ADDENDUM NO. 1

ATTLEBORO WATER DEPARTMENT

WADING RIVER WATER TREATMENT PLANT

CONTRACT NO. 10

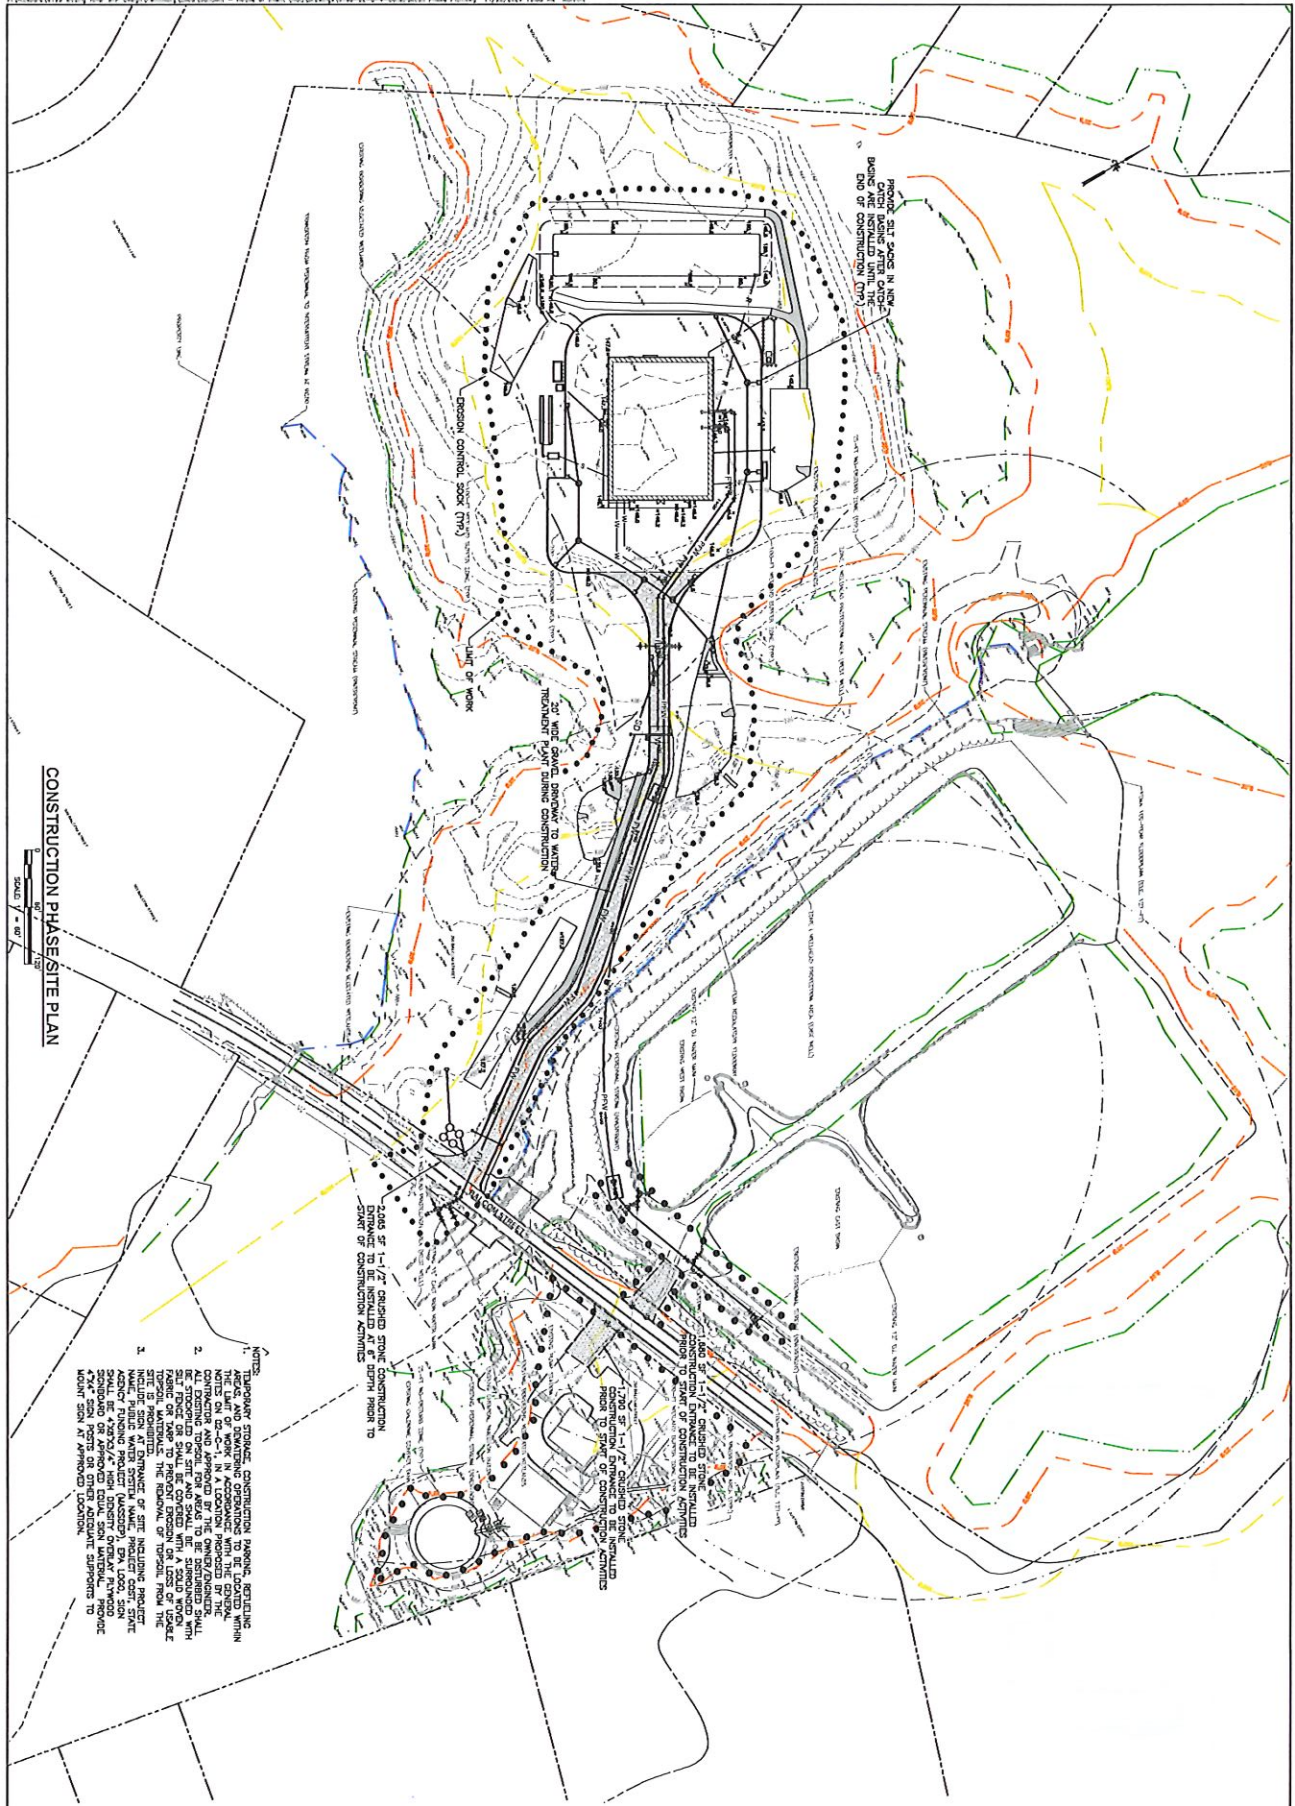
- Q21. Provide contour labels for both the existing and proposed contours for the existing and proposed grading plans.
- A21. *The Civil/Site Drawings 02-C-2 through 02-C-8 are revised and attached to this addendum.*

- 1. Delete Drawings 02-C-2 through 02-C-8 and replace with the attached revised Drawings 02-C-2, 02-C-3, 02-C-4, 02-C-5, 02-C-6, 02-C-7, 02-C-8.
